APPENDIX 4

Formal Objection to SSD-79276958 Proposed Residential Development at 59–63 Trafalgar Avenue and 1A & 1B Valley Road, Lindfield

Native Vegetation and Ecological Significance

The SSD-79276958 Proposed Residential Development at 59–63 Trafalgar Avenue & 1A & 1B Valley Road, Lindfield development site showing its proximity to Gordon Creek and Riparian Corridors shown in **red**.

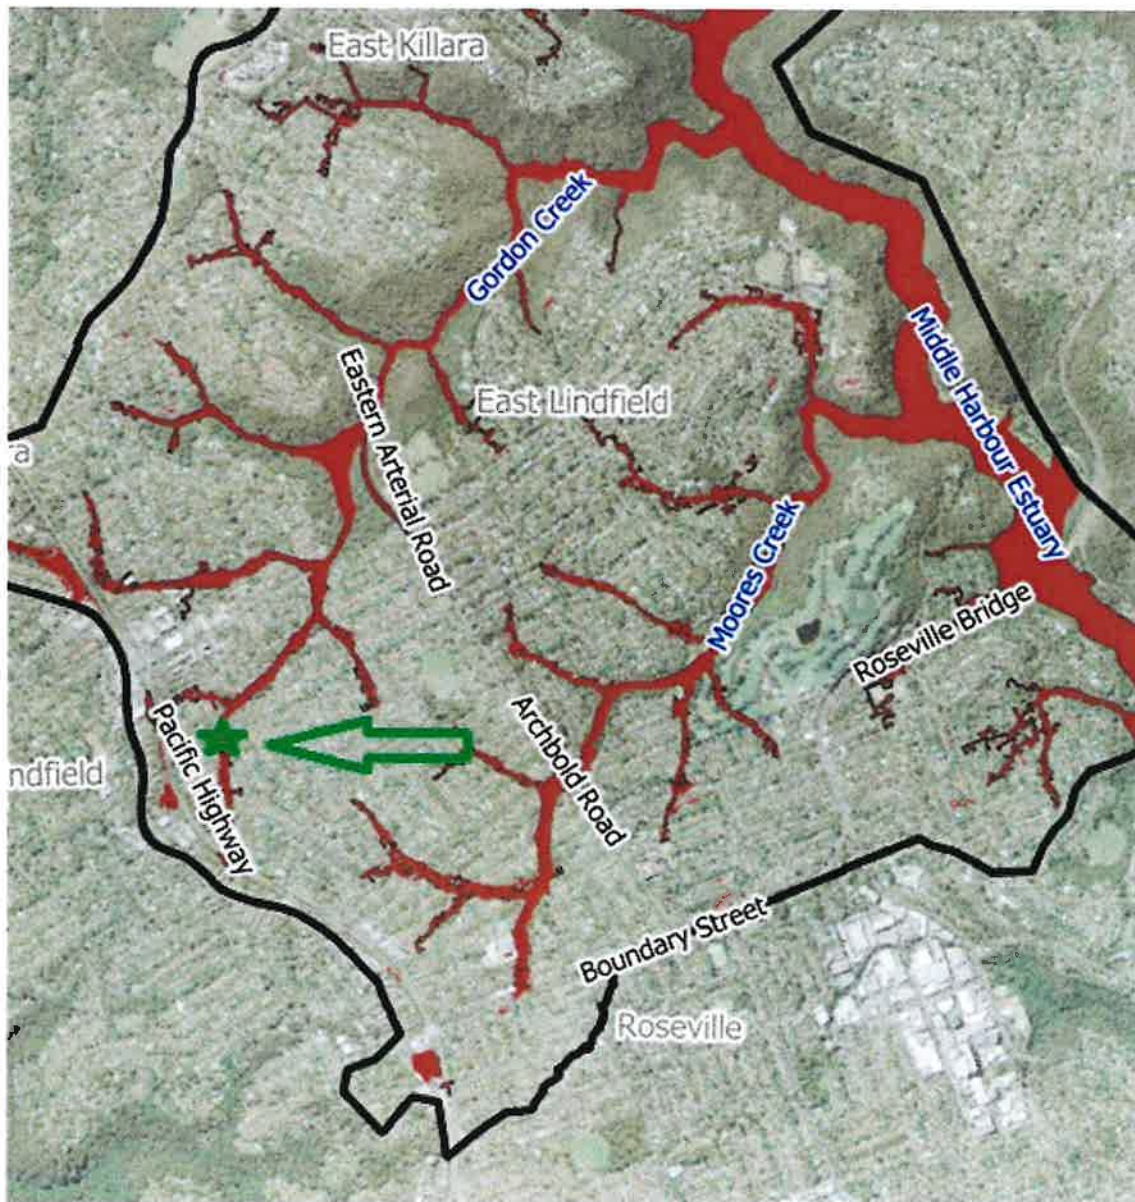
The site adjoins the headwaters of Gordon Creek, one of seven creeks flowing east to Middle Harbour.

The **Ku-ring-gai DCP Greenweb Map** identifies this area as part of a **core biodiversity support and buffer zone**, which includes remnant bushland and a mapped **20m riparian zone**.

It extends further along Middle Harbour Road than was identified by Landmark and their Consultants

Photos taken from 32 Middle Harbour Rd and flowing East towards 32A Middle Harbour Road, Lindfield and onwards.

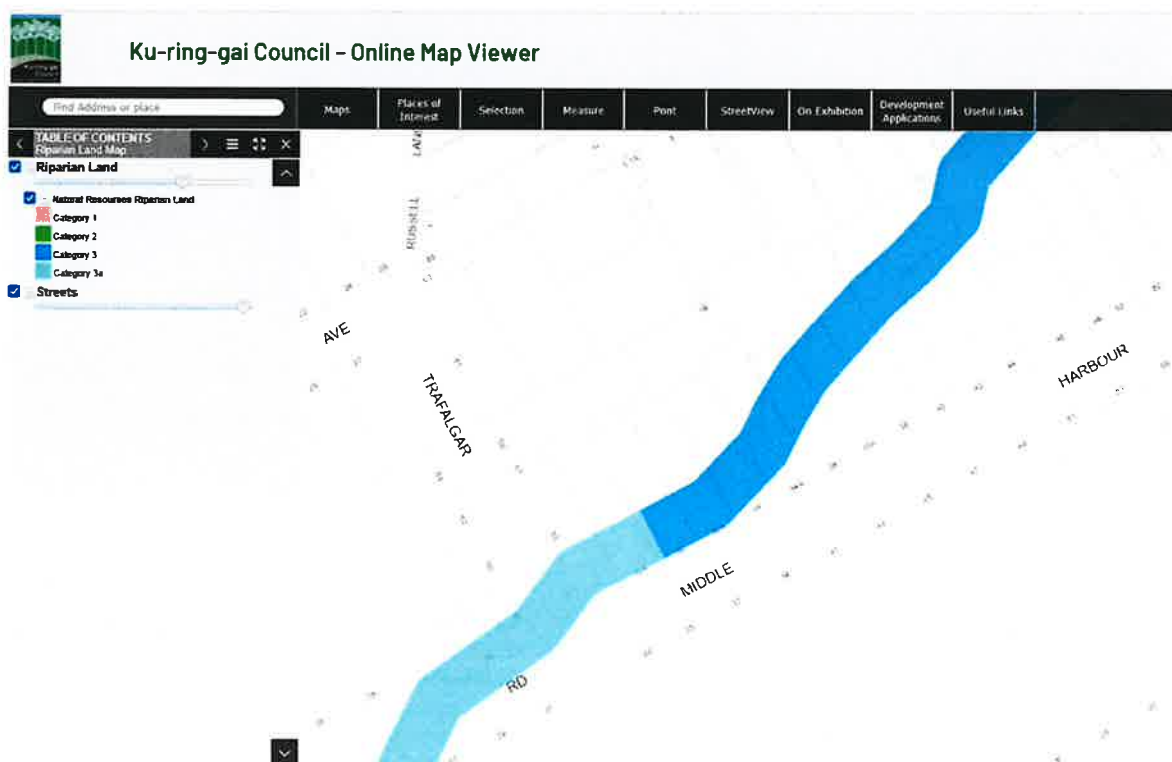
The BDAR (Biodiversity Development Assessment Report) significantly downplays the environmental value and proximity of Gordon Creek by characterising it merely as a “dry gully” located 39 metres away at No. 38 Middle Harbour Road.

This is a misleading and inaccurate representation. In reality, the creek corridor lies less than 50 metres from the proposed development site and forms part of a functioning riparian system that contributes to Ku-ring-gai’s broader ecological network.

Within the Ku-ring-gai LGA, this area should be recognised as a **Riparian Zone Category 3** under local planning and environmental guidelines. These zones, while often narrow and highly modified, remain critical to maintaining downstream water quality and managing flood risk, even when located on private land.

The BDAR’s current characterisation undermines this obligation and must be revised to reflect the true environmental constraints of the site.

Figure 7: Remnant Turpentine (tree 43) in the rear of number 59 Trafalgar Avenue. Note the built form surrounding the tree.

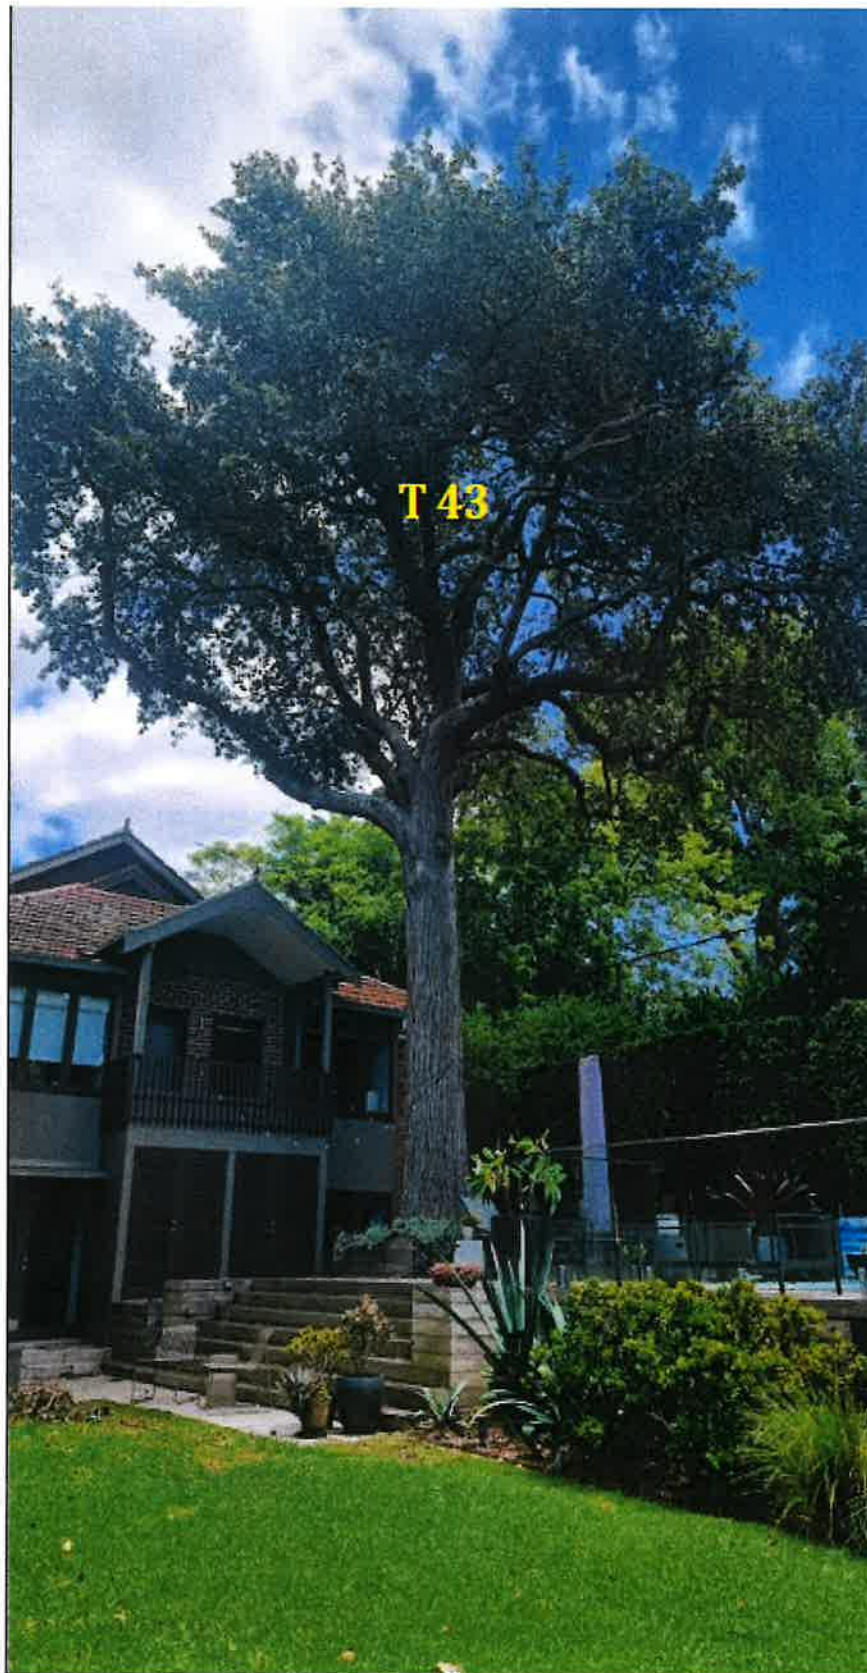
Of critical importance are **two remnant specimens of the Sydney Turpentine (*Syncarpia glomulifera*)**—designated as **T43 and T17**—located near the centre of the site. These trees are representative of the **Sydney Turpentine-Ironbark Forest (STIF)**, a now-fragmented native forest community historically found in this part of the Sydney Basin.

“The most valuable areas of biodiversity are the two remnant STIF trees, T43 and T17. They occur more or less in the centre of the site and are proposed to be removed.”

This is a matter of considerable concern. The **Sydney Turpentine-Ironbark Forest** has been formally listed by the **NSW Threatened Species Scientific Committee** as a **Critically Endangered Ecological Community (CEEC)** under *Part 1 of Schedule 2 of the Biodiversity Conservation Act 2016*. It is also recognised as a critically endangered ecological community under the *Commonwealth Environment Protection and Biodiversity Conservation Act 1999 (EPBC Act)*.

- **Retain Trees T43 and T17 in situ**, incorporating them into communal or public open space;
- **Expand street and side setbacks** to create viable **deep soil planting zones** that allow for ongoing regeneration of native species, including other STIF-compatible plantings;
- Ensure alignment with **state and federal biodiversity protection frameworks**; and
- Demonstrate a commitment to **long-term ecological sustainability and local landscape character** preservation.

Figure 8: Looking to the south eastern corner of the rear garden of number 61 Trafalgar Avenue where the BAM plot was located. The remnant White Cedar (tree 17) is located in the perimeter garden bed.

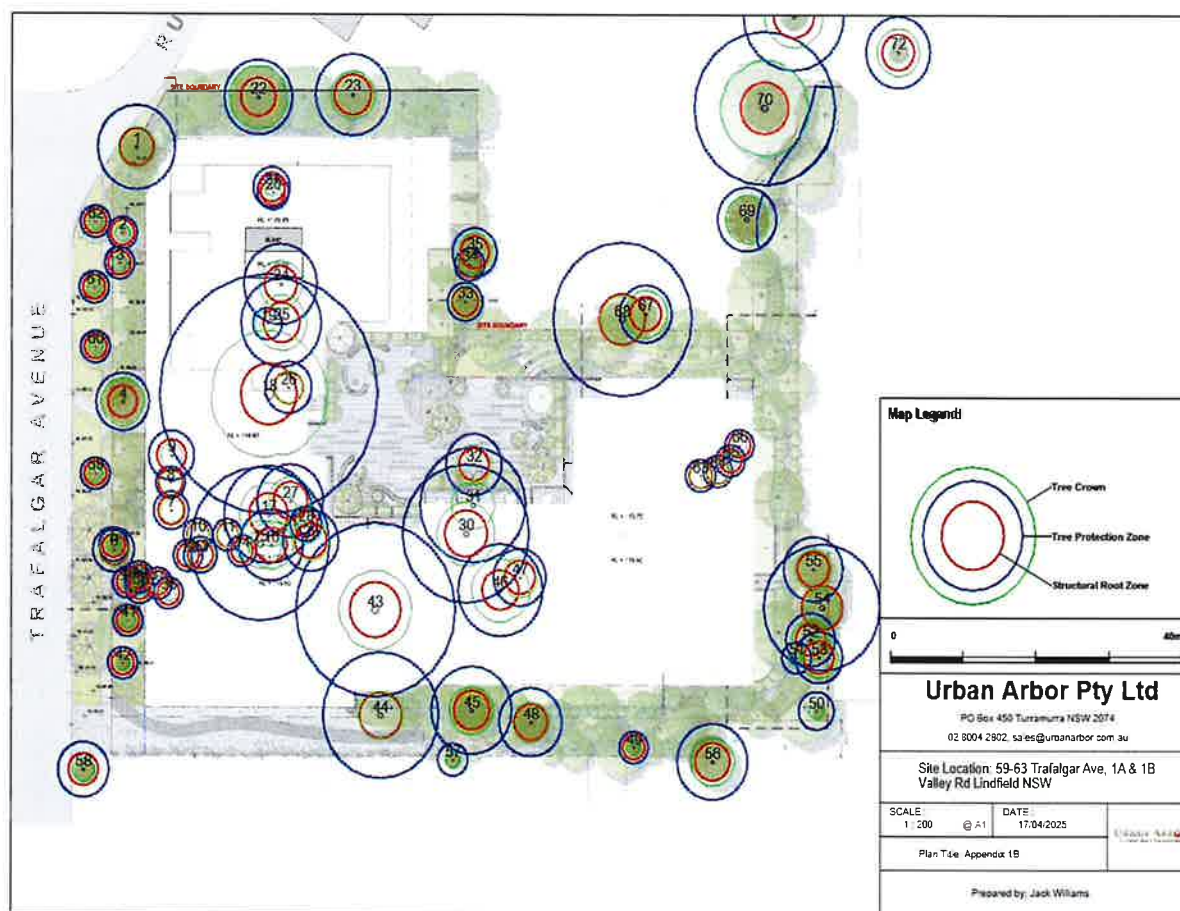
The proposal, as currently designed, seeks to remove both STIF remnant trees (T43 and T17) due to their central location on the site, which is earmarked for built form and does **not contain deep soil planting zones**. The BDAR notes that opportunities for the **retention of native trees are minimal**, due to their spatial distribution across the site. It also states:

However, the removal of the last remaining **naturally occurring STIF specimens** on the site, without a meaningful mechanism for their retention or in-situ rehabilitation, represents a **serious conflict with the principles and objectives** of both State and Commonwealth environmental legislation. Critically, these trees are not replaceable within any meaningful timeframe, and any proposed offsets or compensatory planting will **not equate to the ecological value of mature, remnant trees**, particularly within an endangered ecological community.

Moreover, the proposal **does not adequately consider redesign alternatives** that would allow for the **integration of the STIF trees within the landscape or building setbacks**. Given the location of the trees in the central portion of the site and the absence of deep soil in this area, the development must consider **expanding the depth of street and side setbacks** to enable **deep soil zones** suitable for ecological enhancement and vegetation retention. Without this, the opportunity to support and restore remnant vegetation of this conservation value will be permanently lost.
